**Folder [20240320 Williamson Park Pond Stormwater Detention Basin Alternate Design (2)]**

Folder [Williamson Park Pond Weir]

**Second alternate design for Williamson Pond**

#### Freehand sketch cross section of Williamson basin

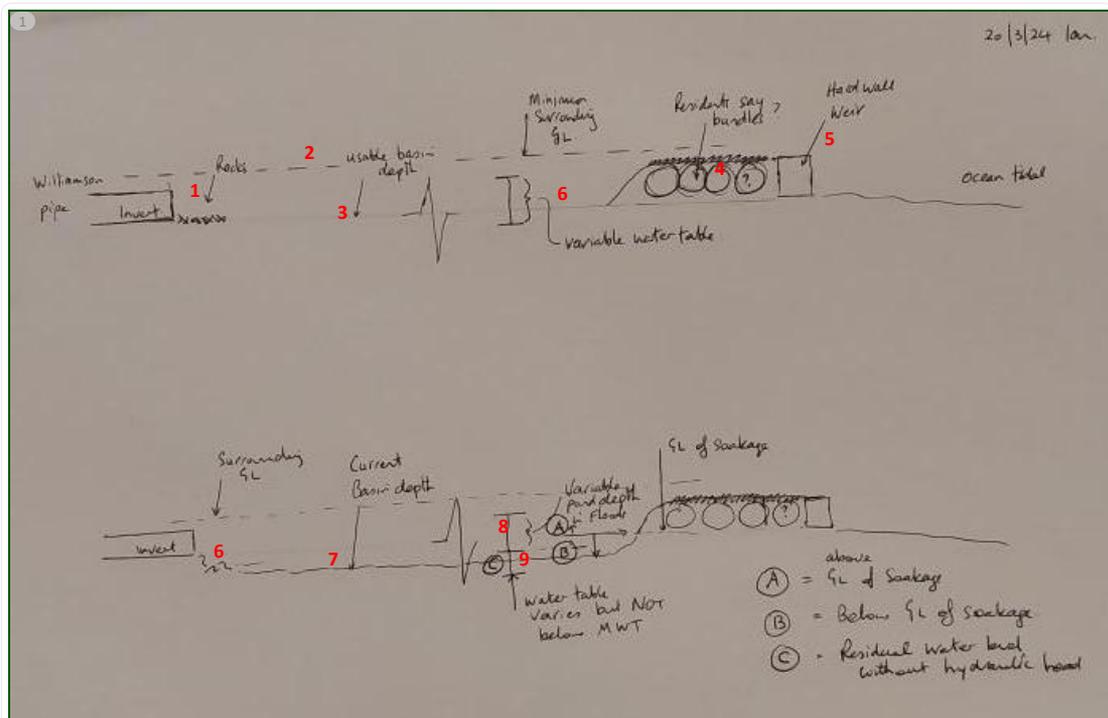
**Top image** is my extrapolation of what I believe it looked like at design/build.

1. Is invert of 1.05m dia discharge pipe ex Williamson/Ocean. The rocks we see are likely to stop erosion when outflow is increased.
2. Is surrounding GL of park land
3. Is the basin depth - ie 2-3 times area is water storage potential (minus weir depth to GL)
4. Is a soakage system - best I can get from residents is its a series of wrapped devices - likely Geotech around something. It has a plastic grate surface to prevent erosion and the Geotech. At design it would not be sensible to have these below the basin depth as they would then be in the water table. ie the expected depth is just below the invert for fall from one end to the other
5. Is the weir height which will only operate when discharge rate exceeds the absorption back into the surrounding water table plus what travels through 4 the soakage devices.

Since the basins construction we believe was around the later 1970's when the Ocean outfall pipes were cut back residents say a new weir was constructed 2m back from the original one. The remnants exist so I accept this. They date this around 5 or so years ago. I cannot confirm this.

**Bottom image** is my extrapolation of what I believe it now looks like. We were not given copies of the Metis workings so if heights to RL or whatever need refining then do so.

6. Rocks have sunk down but show no silting
7. Basin depth now lower - Bruce from EPL stated they remove 150mm-200mm of the basin at each maintenance event.
8. Variable pond depth in flood - before basin depth was lowered
9. Line RL of current water table NB: this RL line is below the old basin depth and below the soakage devices so remains as ponding corresponding to surrounding water table level

The issue is the maintenance has changed the operation of the original design by lowering the basin depth into the water table.

A: When water level is above A the soakage devices can work - if they have been maintained

B: Below this line the soakage through device does not work so to remove this water relies on a lower surrounding water table - which is variable depending on preceeding rain events volume/time

C: The continuation of current maintenance regime will cause more still water depth and be

undesirable.

(i) clean out the basin

(ii) clean out the wall of the soakage device and likely remove 2/3 of them to speed up through soakage in heavy rains

(iii) backfill the basin to its original depth at invert level

(iv) create a cleaning mechanism like a concrete pit to clean out any residual sands that escape being caught in the road cesspits.

(v) create a new maintenance regime that does not alter its original design.
